SMDC Planning Reference –	SMD/2022/0343		
Site Name –	Totmonslow Farm Solar Facility		
Summary of proposals -	Photo voltaic array facility with control equipment		
Consultation Note Subject –	Landscape and Visual Matters		
Planning Case Officer –	Arne Swithenbank		
Landscape Comments Prepared By –	Stuart Ryder of Ryder Landscape Consultants		
Date of site visit —	2/9/22	Date of response	22/9/22
Recommendation –	Seek Clarification – Of proposed landscape mitigation measures / treatment near footpath / cumulative effects from A50

Totmonslow Farm Solar Facility – Landscape and Visual Consultation

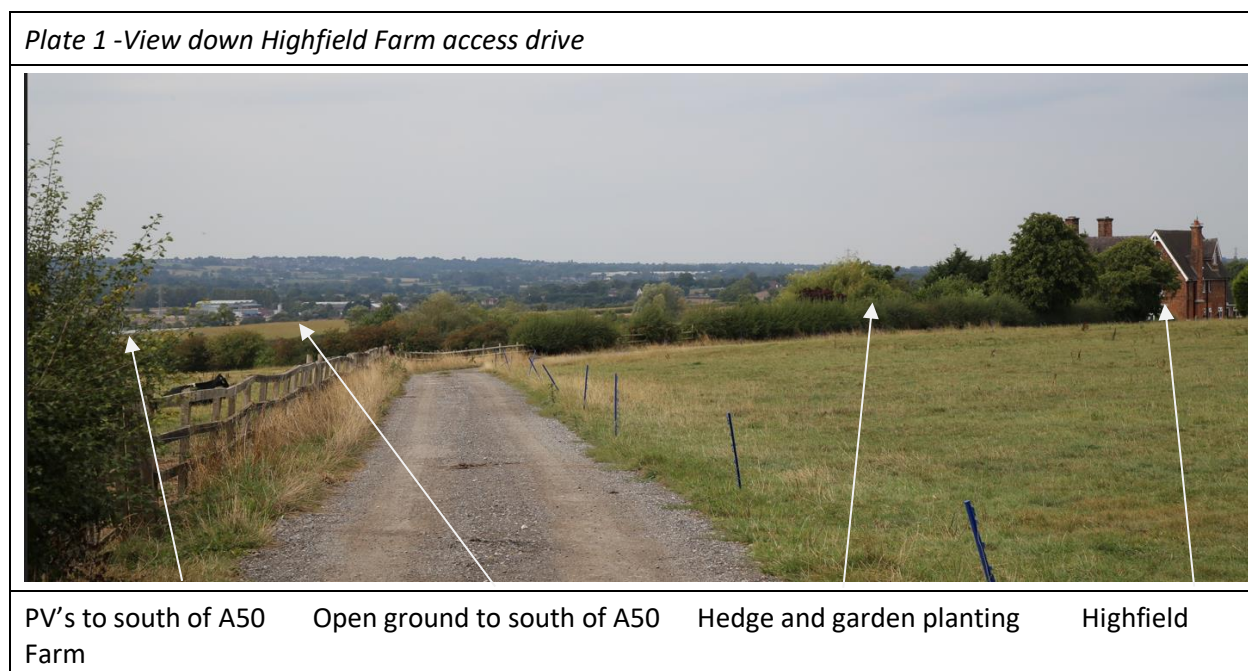
The ability to retain the existing hedgerow network as a multitude of strong planting buffers is acknowledged and in reality the numerous hedgerows will likely screen views to the PV arrays from the outset as discussed further in the visual effects section below. The point of greater landscape concern however is what state the hedgerows are likely to be in with the adjacent land use changing from agricultural to energy production. The former requires regular hedgerow maintenance (cutting and shaping) which the latter does not. The Applicant should explain by way of detailed landscape management proposals how they are proposing to keep the hedgerows within and around the Site as

hedgerows rather than overgrown, straggly tree lines. This same concern about the field ponds can be expressed because they too can succeed to woody areas without ongoing management.

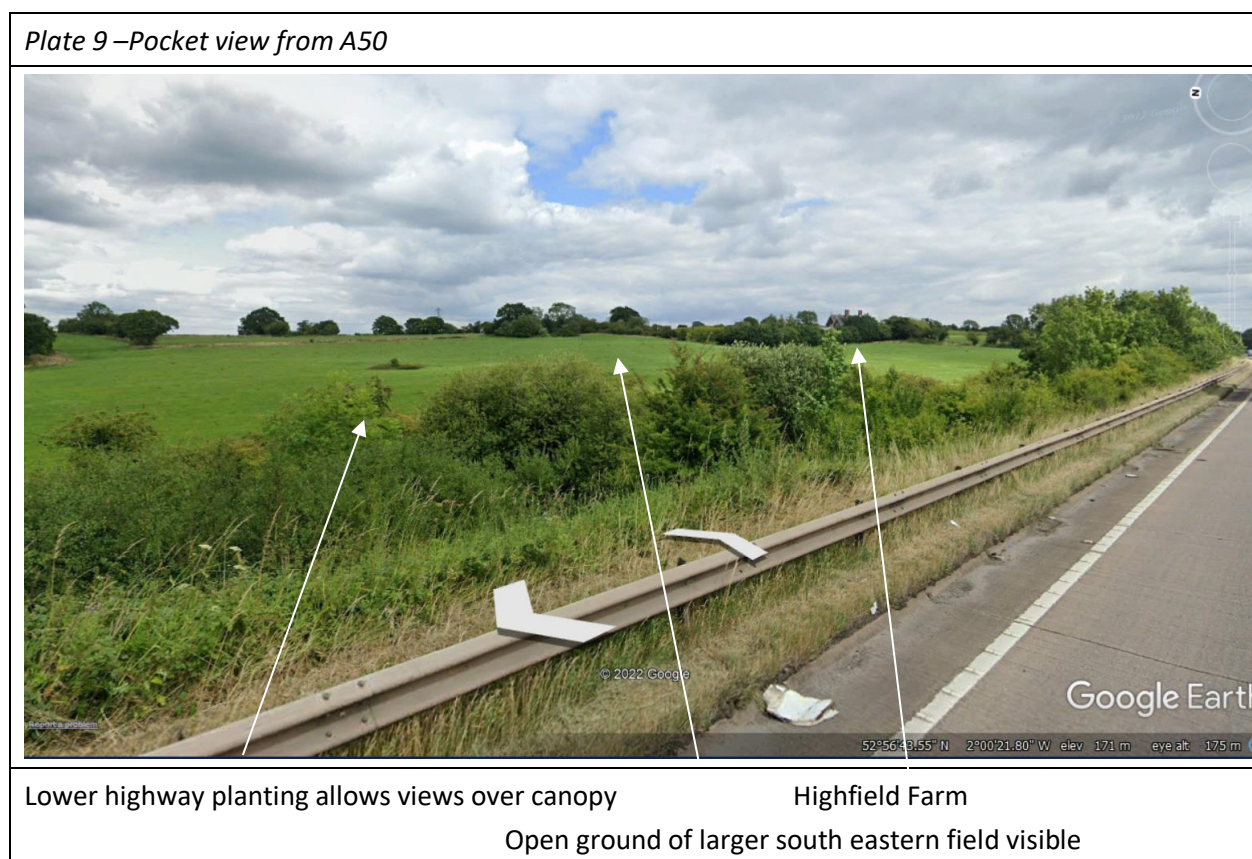
This important transport route allows a view to be taken to the raising ground to the north of the A50 where highway planting is thin and before the local cutting is entered into. Even though a fleeting view it will allow understanding that there is a PV facility to that side of the A50. The landscape proposals do not show any additional screen planting to reduce sight into the south eastern PV field. The view is limited in duration given the speed of the A50 road users and most of the route past the PV facility is either screened by highway planting, embankment cutting or both. However the sudden appearance of the view to east bound travellers will add a 'surprise' element to the unexpected feature adding to its notability.

Plate 9 below is an extract from Google Earth and even taking into account the higher eyeline of the camera at 2.4m there is still a clearly visible view into the lower south eastern field running up to Highlands Farm on the skyline.

Screen planting of this view is recommended, possibly with quick growing tree species set off the highway land and within the field margin. If they are considered to cast too much shade on the PV's the shaded area could be a further BNG area.

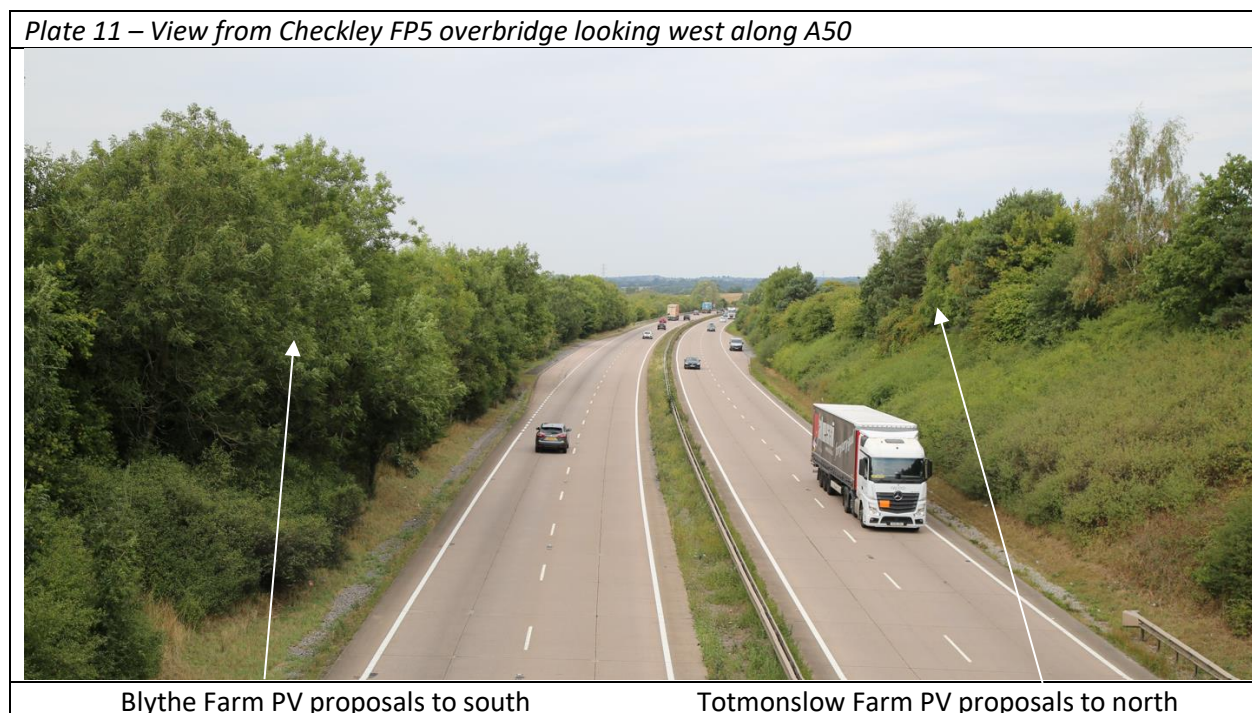
There are two sets of cumulative effects to consider. The first with the existing Blythe Farm PV facility (SMD/2014/0197) and the second with the potentially extended Blythe Farm PV facility (SMD/2022/0160). Realistically there is only the A50 where both facilities can be seen from a close distance and possibly from the access drive to Highlands Farm.

The ubu LVIA reports on cumulative effects at Section 7 and does identify the existing and pending consents. However it is not definitive in its comments and reports cumulative effects are 'unlikely'.

Further information on the likelihood of seeing both solar parks on either side of the A50 would be useful in the determination of this application.
